CONVAIR  
A Division of General Dynamics Corporation  
San Diego, California

COMMERCIAL CHANGE PROPOSAL

SPEC NO: ZD-22-002

CUSTOMER: Hughes Tool Company

FIGURE 1-1  
GENERAL ARRANGEMENT  
MODEL 22 JET TRANSPORT

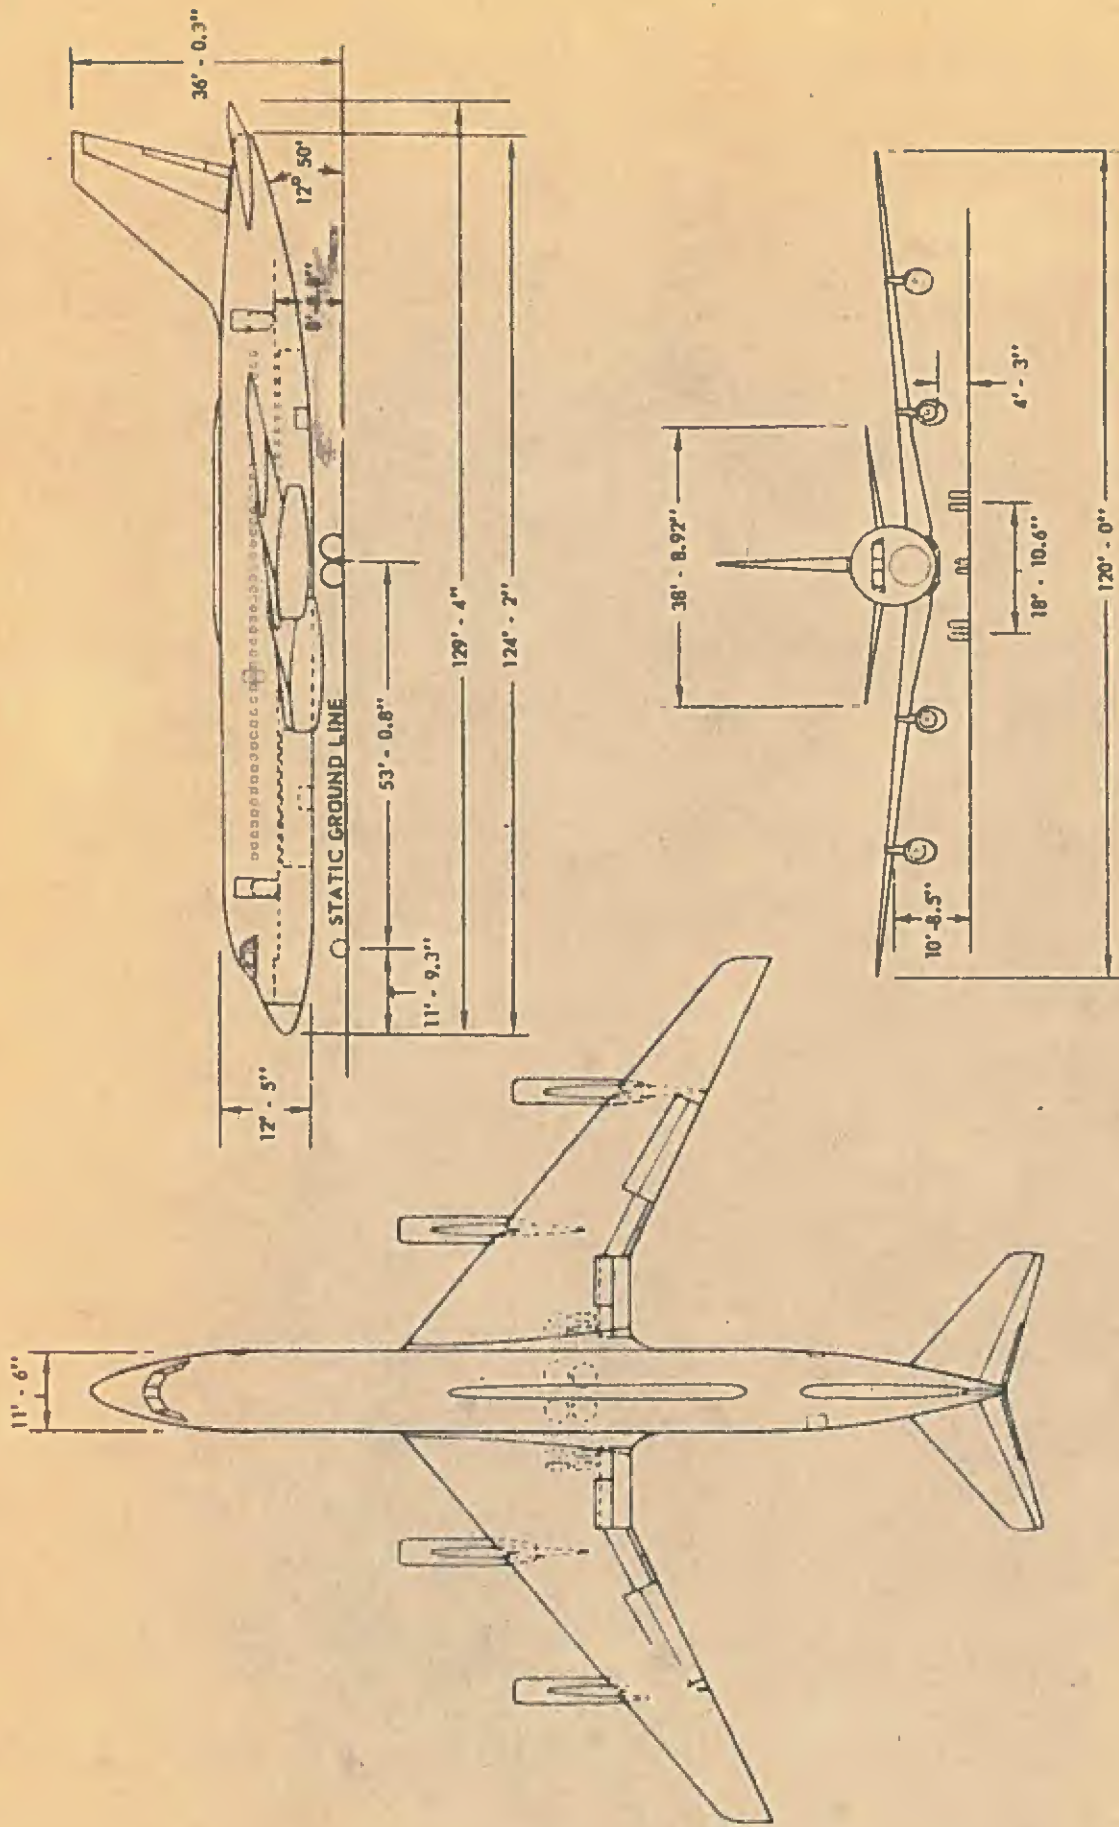
Page 2A, Figure 1-1, GENERAL ARRANGEMENT, MODEL 22 JET TRANSPORT

Enclosure: (A) Four (4) copies Figure 1-1, GENERAL ARRANGEMENT OF MODEL 22 JET TRANSPORT
